LION PETROLEUM CONVENIENCE STORE

HAMBLEEN PLAZA

LEE'S SUMMIT, MISSOURI

Revisions
1. 11-28-22
2. 05-15-23

SANITARY ISOMETRIC 2

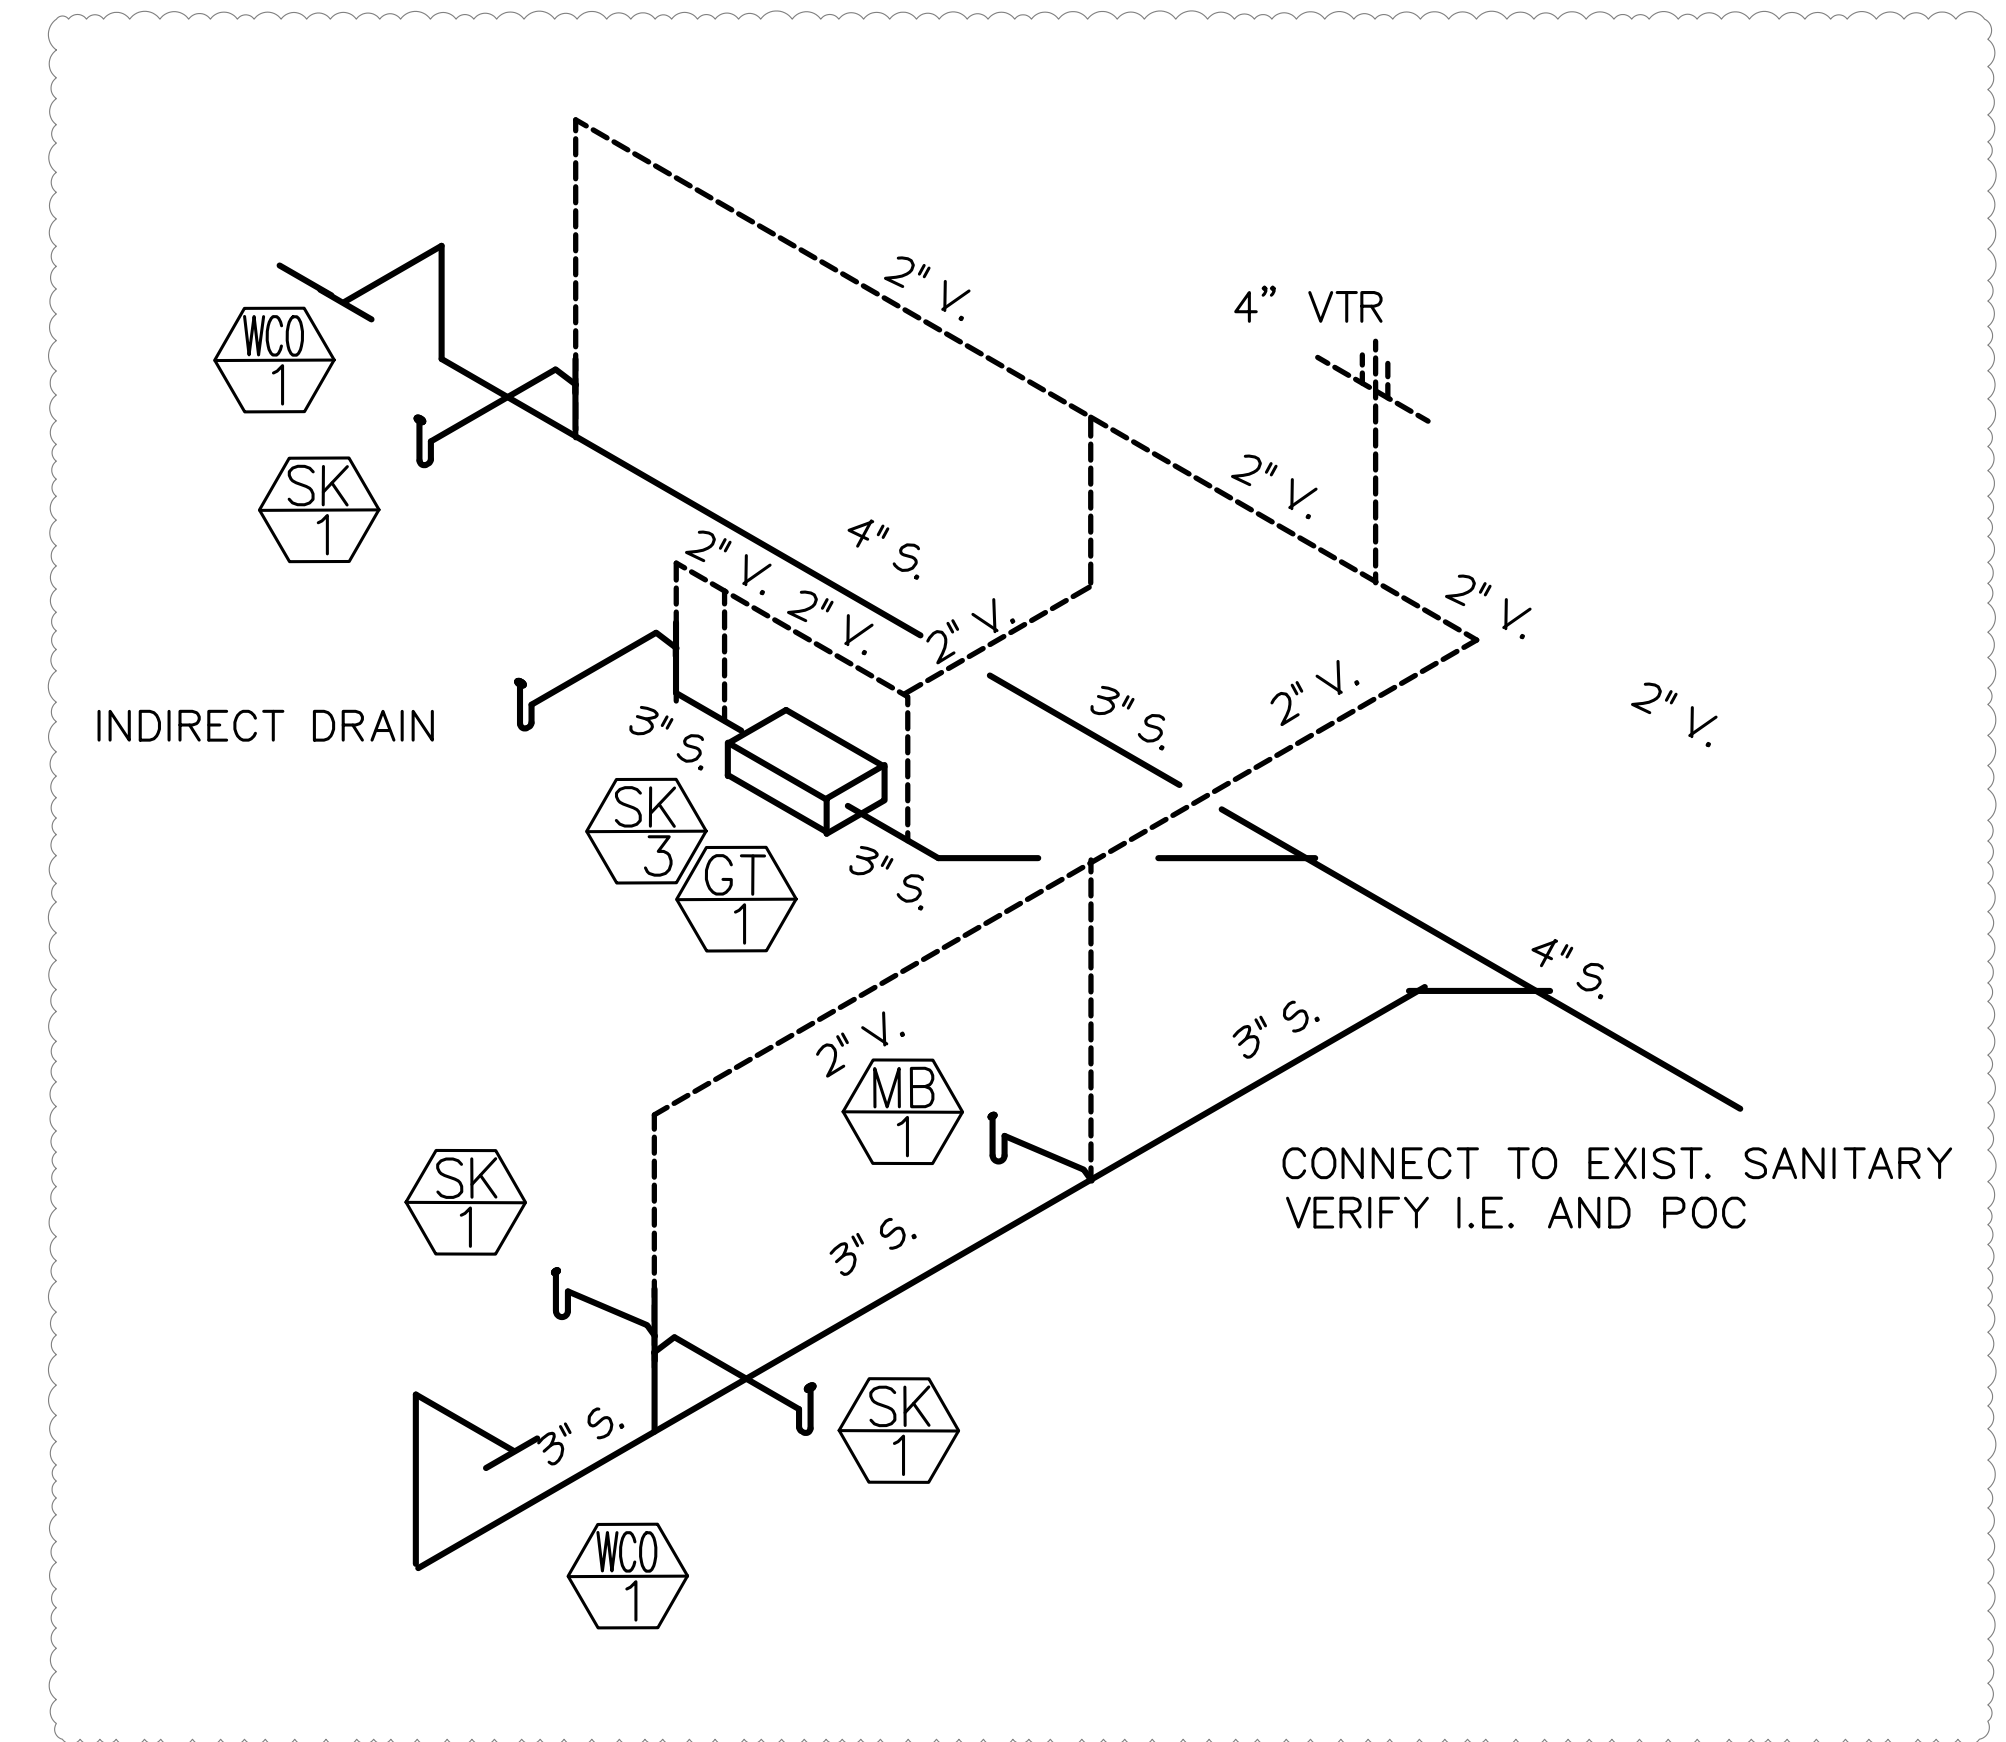
- ITEM 15 FROM JOE FROSSE: EXPANSION TANK SHOWN ON PLUMBING SCHEMATICS SHEET P2
- ITEM 16 FROM JOE FROSSE: ADDED NOTE ABOUT INDIRECT CONNECTION ON ISOMETRIC ON SINK SK-3 SHEET P3
